**Stage 1 Quality/Safety Audit (& Designer
Feedback Form)**

Title: **QUALITY AUDIT**

Proposed Large Scale Residential Development, Greenhills, Dublin 24.

Report reference: **2042R02**

Drawing NRB TA-001 Rev C

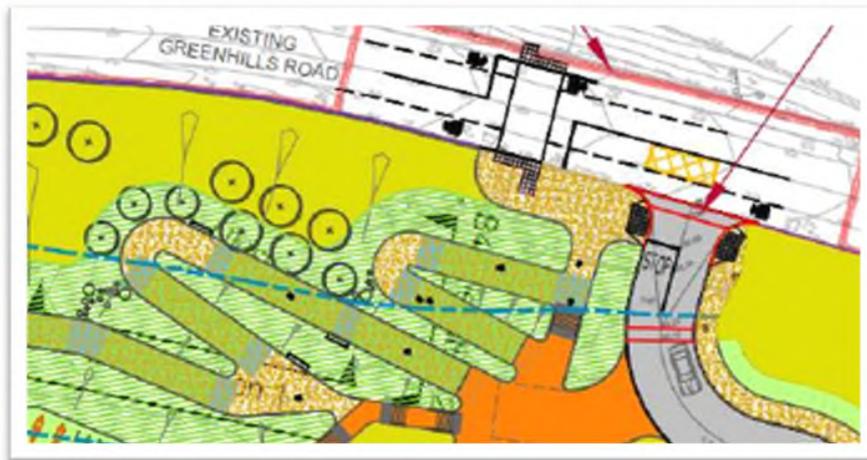
It is recommended that a suitable Clear Zone be provided to avoid the need for a safety barrier.

3.1	Yes	Yes – A suitable Clear Zone will be provided, in accordance with TII’s DN-GEO-03036. This will include a more level section close to the road edge. This slight change to the design will be undertaken during the Detailed Design Stage.

Drawing NRB TA-002 Rev C

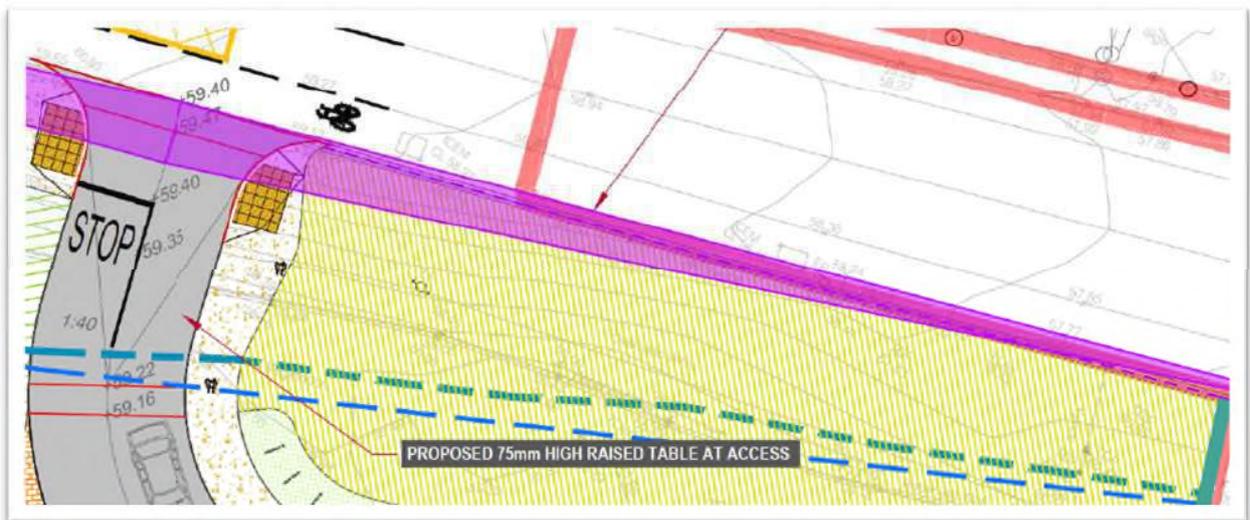
It is recommended that the visibility splays be kept free from obstacles.

Drawing NRB-TA-001 Rev C.

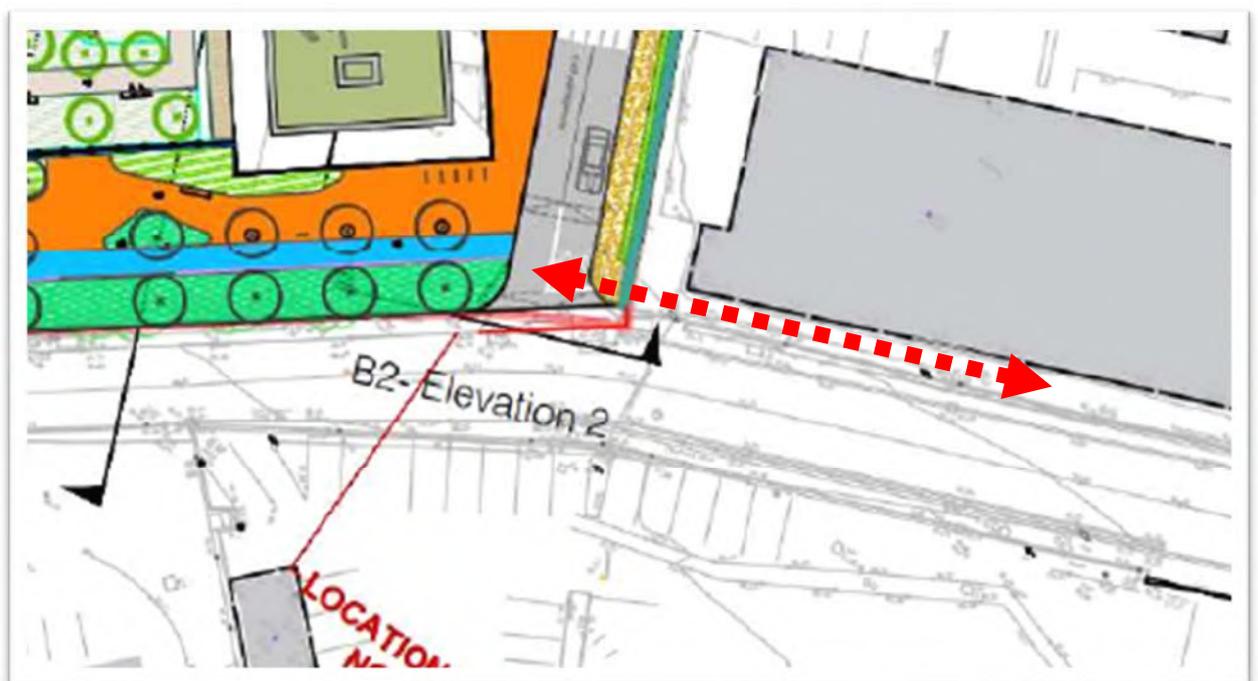
It is recommended that a pedestrian crossing be provided to the footpath on the opposite side.

Drawing NRB-TA-004 Rev C.

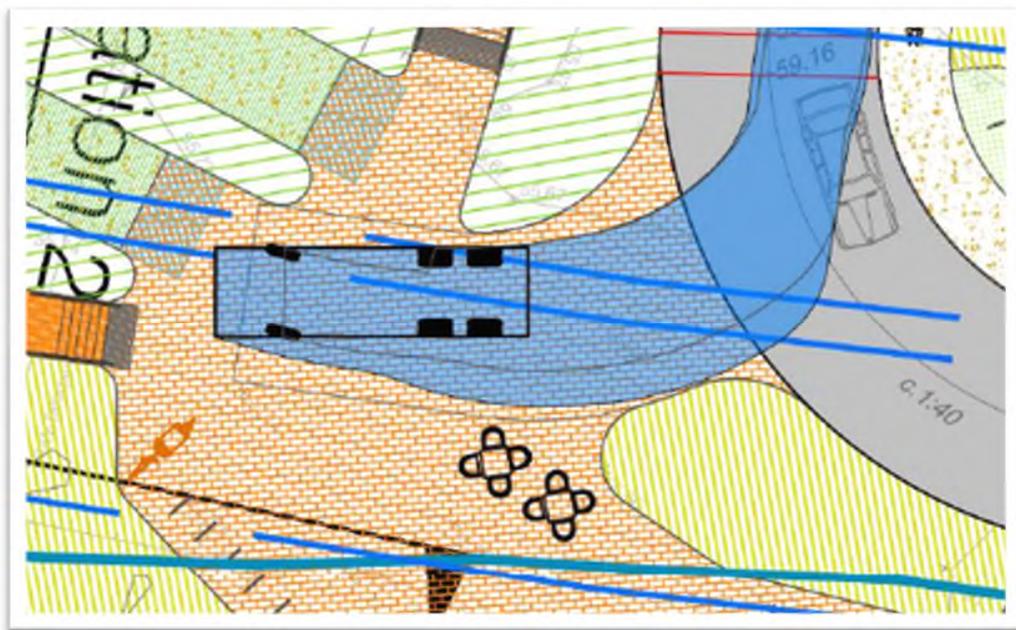
The swept path of a refuse vehicle is shown on the drawing. It is unclear where the refuse bins will be stored prior to collection and prior to being brought back to their storage area. It is also unclear what routes will be taken to get bins to their collection point given the amount of steps, street furniture and landscaping proposed.
